SOLICITATION AMENDMENT

Title - Sujet Property and Facility Management	
Solicitation No. - N° de l'invitation 08C54-170130/A	Amendment No. - N° modif. 010
Client Reference No. - N° de référence du client 20170130	Date 2017-07-28
GETS Reference No. - N° de référence de SEAG PW-\$\$FK-302-73065	
File No. - N° de dossier fk302.08C54-170130	CCC No./N° CCC - FMS No./N° VME
Solicitation Closes - L'invitation prend fin at - à 02:00 PM on - le 2017-08-14	
Time Zone Fuseau horaire Eastern Daylight Saving Time EDT	
F.O.B. - F.A.B. Plant-Usine: <input type="checkbox"/> Destination: <input type="checkbox"/> Other-Autre: <input type="checkbox"/>	
Address Enquiries to: - Adresser toutes questions à: Kraya, Jeahan	Buyer Id - Id de l'acheteur fk302
Telephone No. - N° de téléphone (819) 420-5351 ()	FAX No. - N° de FAX () -
Destination - of Goods, Services, and Construction: Destination - des biens, services et construction:

This Amendment 010 is raised to answer questions from the industry.

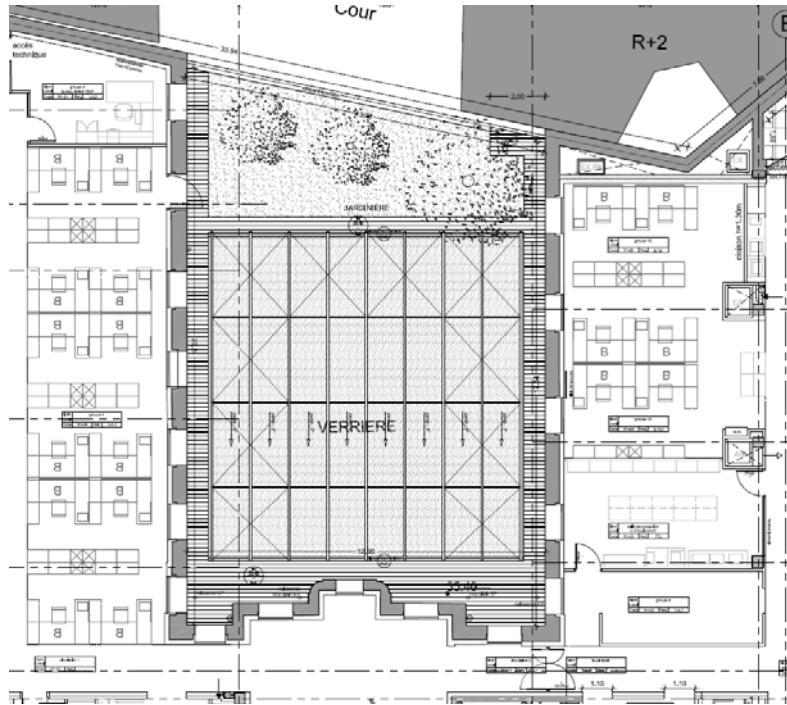
Q18: Could you share with us the recommendations for maintenance of the manufacturer concerning the cleaning of the canopy? What is the maximum weight on the ground for a nacelle in order not to damage your facilities? Is what you put us a cot at disposal for the cleaning of the canopy?

R18: The interior (lower) surface of the glass canopy (verriere) will be cleaned using a GenieLift (nacelle) (The lift has not yet been purchased). The exterior (upper) surface will be cleaned using a telescopic rod. There is a walkway outside on three sides of the glass canopy that can be used to access the glass surface for cleaning. The glass surface of the glass canopy is approx. 11m x 11m (see below). It is not possible to walk on the glass surface.
